SANITARY SEWER EXTENSIONS

NORTH WOODLAWN ADDITION

BEL AIRE IMPROVEMENT DISTRICT

CITY PROJECT NO. DBKW705019
PRIVATE CONTRACT

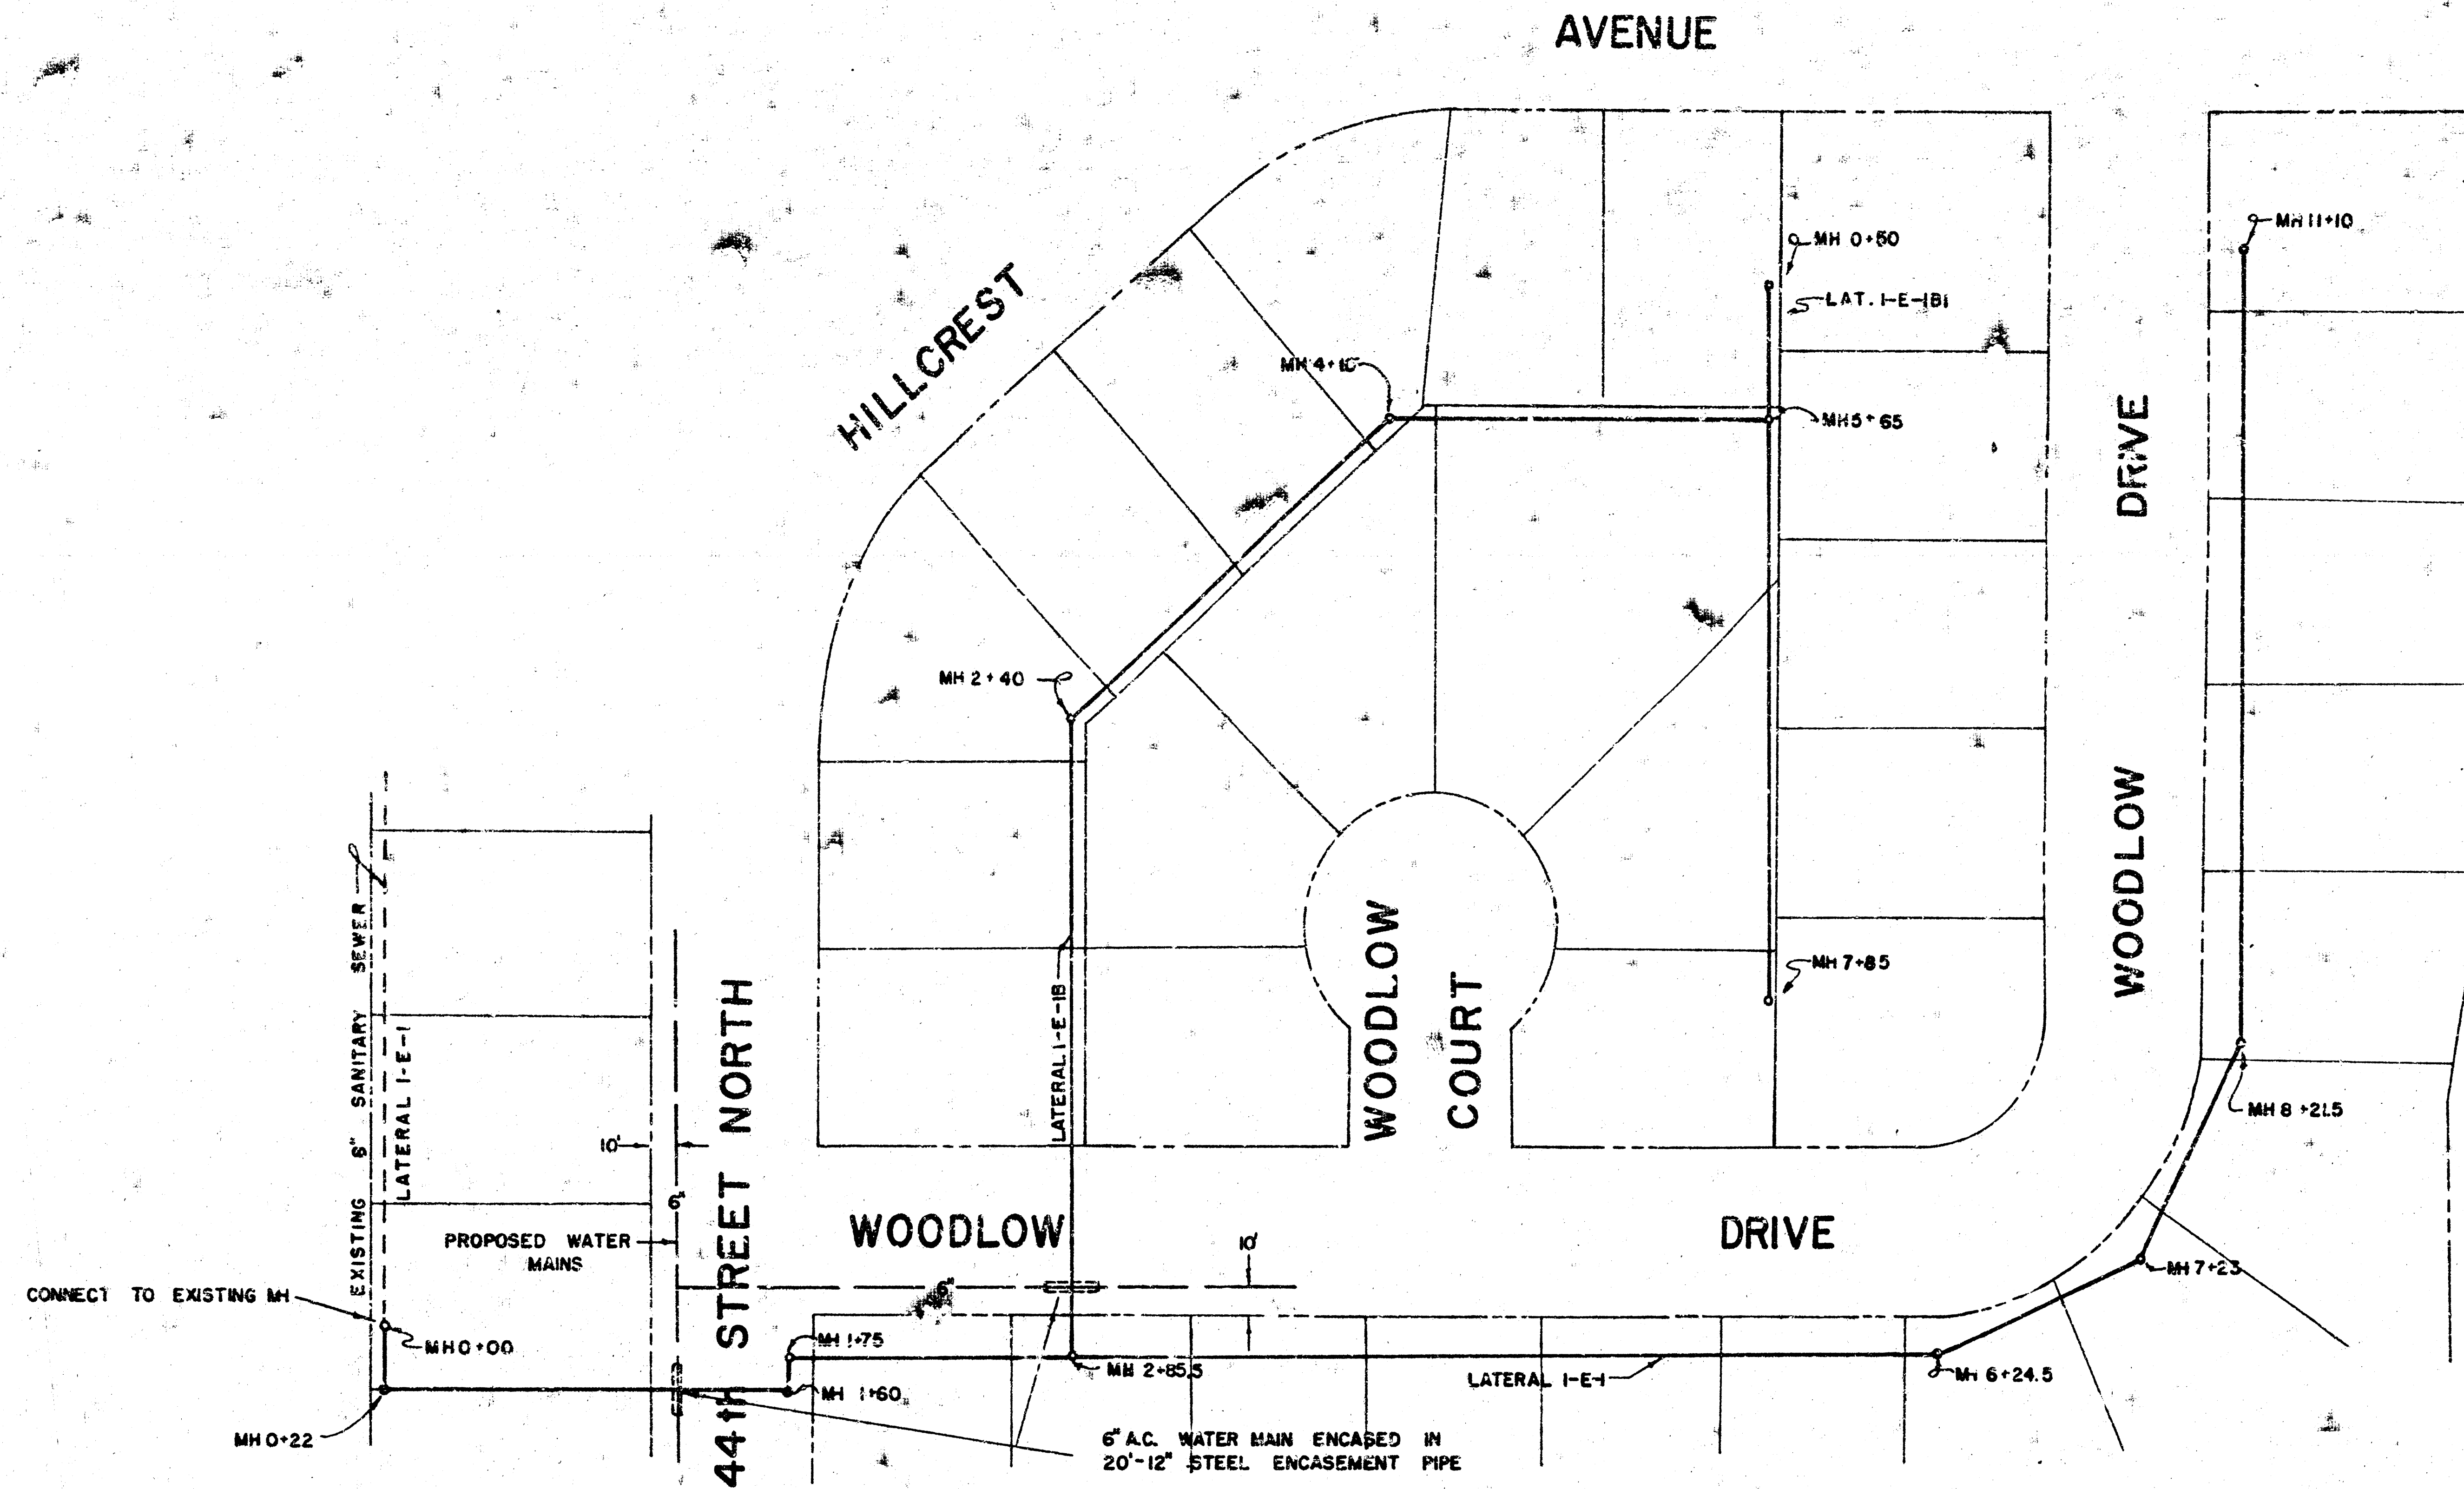
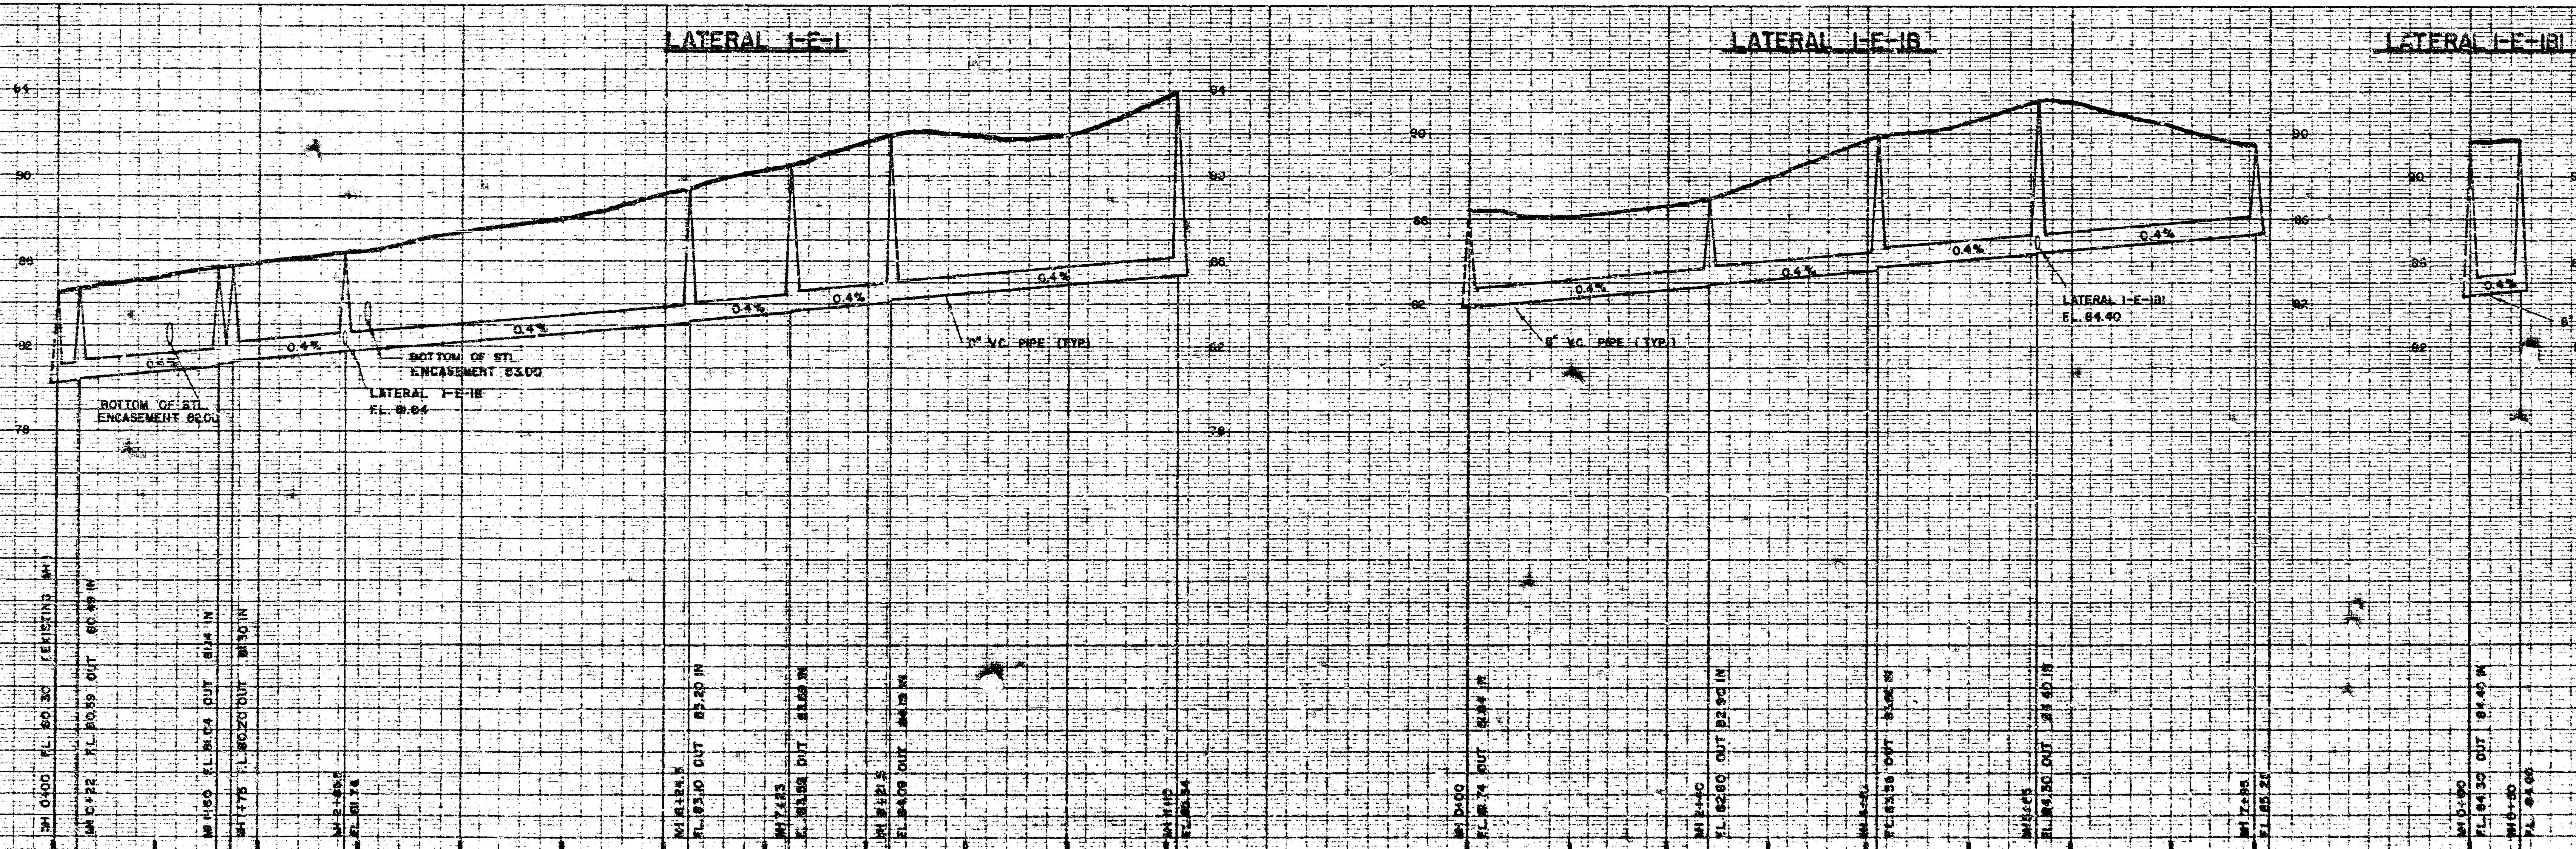
Enclosed are the "As Built" maps of the sewer extensions in North Woodlawn Addition and Fountain Hills Addition. The pipe grades of the sewer extensions in North Woodlawn were constructed exactly the same as shown on the original plans except for Lateral 1-K-1a. F.I. grades at the manholes of this lateral are as follows:

MH 0+00	78.72
MH 2+15	79.58
MH 4+90	80.68 out 80.78in
MH 7+15	81.68
MH 9+60	82.66
